The Commission has issued the enclosed Amendments Nos. 103 , 103 , and 100 to Licenses Nos. DPR-38, DPR-47 and DPR-55 for the Oconee Nuclear Station, Units Nos. 1, 2 and 3. These amendments consist of changes to the Station's common Technical Specifications (TSs) in response to your request dated October 28, 1981, as supplemented on October 29, 1981.

These amendments revise the TSs to allow full power operation of Oconee Nuclear Station Unit 2 with the Axial Power Shaping Rods in the fully inserted position.

ATTACHMENT TO LICENSE AMENDMENTS

SAFETY EVALUATION BY THE OFFICE OF NUCLEAR REACTOR REGULATION

APSR POSITION LIMITS FOR  
 OPERATION  
 FROM  $150 \pm 10$  EFPD TO  
 $390 \pm 10$  EFPD  
 Unit 2 - 30  
 OCONEE NUCLEAR STATION  
 Figure 3.5.2-4B2

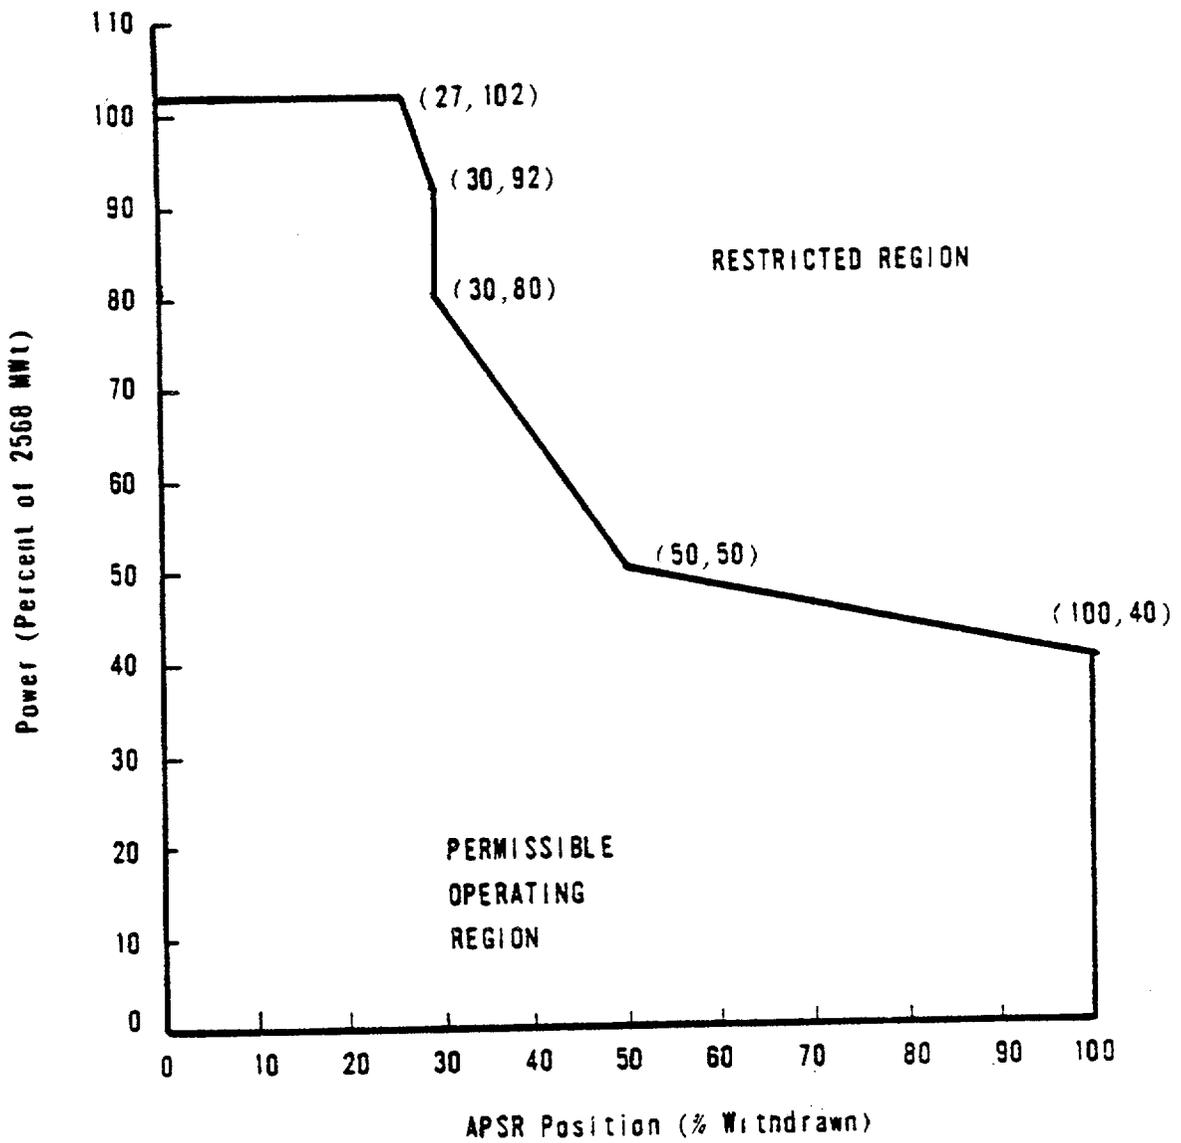
Replace page 3.5-25a of the Appendix "A" Technical Specifications with the attached page. The revised page is identified by amendment numbers and contains a vertical line indicating the area of change.

The current ONS TS limits associated with APSR position (contained on Figure 3.5.2-4B2) for Oconee 2 operation require the APSRs to be withdrawn 6% from the fully inserted position for full power operation. Operation up to 80% of full power operation is permissible with the APSRs in the fully inserted position. Because of the concern mentioned above, Duke, by letter dated October 28, 1981, requested a change to allow full power operation with the APSRs in the fully inserted position.

The present requirement for 6% withdrawal of the APSRs was discussed by Duke in a supplemental letter dated October 29, 1981. This letter states that the reason for the required slight withdrawal is twofold: 1) to prevent unacceptable power peaking toward the end of fuel cycle, and 2) to prevent the APSRs from becoming trapped in the fully inserted position by power imbalance and peaking considerations.

The analysis performed by B&W indicated unacceptable power peaking could occur if the APSRs were fully inserted in the core early in the fuel cycle. Reexamination of the analysis indicates that for end of cycle, accounting for the control rod and APSR positioning that has been maintained during this cycle, unacceptable power peaking should not occur with the APSRs fully inserted. (The power peaking limitations define the linear heat rate values used as initial assumptions in the LOCA analyses performed in accordance with Appendix K to 10 CFR 50.46.) Therefore, operation with the APSRs in the fully inserted position will not violate the limits used in the LOCA analyses.

We have reviewed this information and the existing TSs. Since TS limitations will remain unchanged for Xenon Reactivity (3.5.2.6) and Power Imbalance (3.5.2.7), assurance is maintained that unacceptable core power configurations will not develop. In addition, no reactor protective features will be changed because the APSRs are not included in the automatic shutdown system. Therefore, based on the considerations discussed above and the fact that only a short period of operation remains during Cycle 5 operation, we find the proposed change to the ONS Unit 2 APSR position limits to be acceptable.
